GULF STATES UTILITIES COMPANY

River Bend Station - Unit 1
Refer to: Region IV
Docket No. 50-458/90-27

REPLY TO NOTICE OF VIOLATION 50-458/90-27
LEVEL IV

Fig. 3.3.4—Workmanship tolerances in assembly of groove welded joints

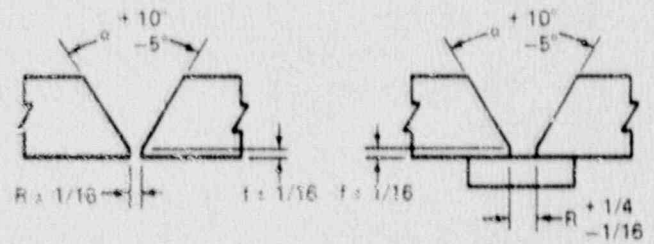
Contrary to the above, WPS-W1.1-01, which was designated as an AWS D1.1 prequalified welding procedure, was utilized in an application where the weld joint details did not conform to the requirements of Section 2 of the Code. Specifically, the joint configuration used for welding the flange to outer plate on a modification to the diesel generator tornado damper separator (Modification Request 86-1389) did not conform to the Section 2 prequalified joint details for included angle, thereby invalidating the procedure as prequalified. It was also determined that General Welding Procedure SPP-7002, Revision 1, which was referenced in WPS-W1.1-01 for joint fitup tolerances was inconsistent with the requirements of Section 2 of the Code; for example, the allowable root opening for Joint A-TC-U4a in SPP-7002 exceeded that permitted by the AWS D1.1 Code for a prequalified joint.

1. American Welding Society (AWS) Code D1.1 Paragraph 2.9.2 allows variation on design and detail drawings within the limits as specified in Paragraph 3.3.4 of AWS-D1.1. GSU's weld joint details are specified in Attachment 6 of procedure SPP-7002. These details show the total variation allowed by Paragraph 3.3.4 and thus are in conformance with the code requirements.

As can be seen these allowable joint variations are identical to those identified in Attachment 6 of SPP-7002. GSU has identified no inconsistencies in SPP-7002 with respect to AWS D1.1 prequalified weld joint details.
